Technical Service Information

THM 440-T4 LOWER CHANNEL PLATE CHANGE

Figure 1

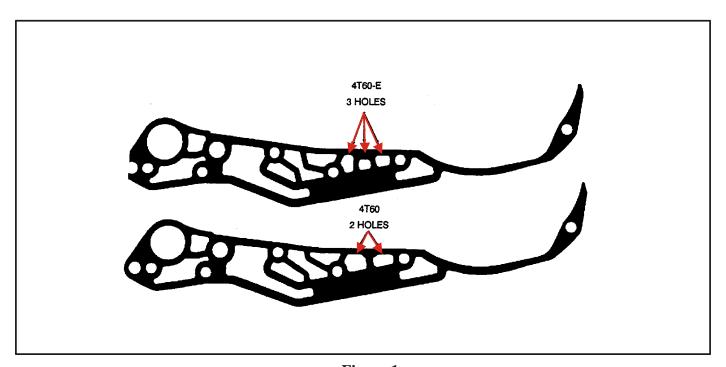
CHANGE: Additional feed hole for revised hydraulics.

REASON: Elimination of governor oil and addition of drive servo apply oil and manual 2-1 servo oil

passages.

New gasket has revised feed hole locations to accommodate channel plate and case changes

(FIGURE 1).

The "'4T60" gasket WILL interchange with the "4T60-E" gasket.
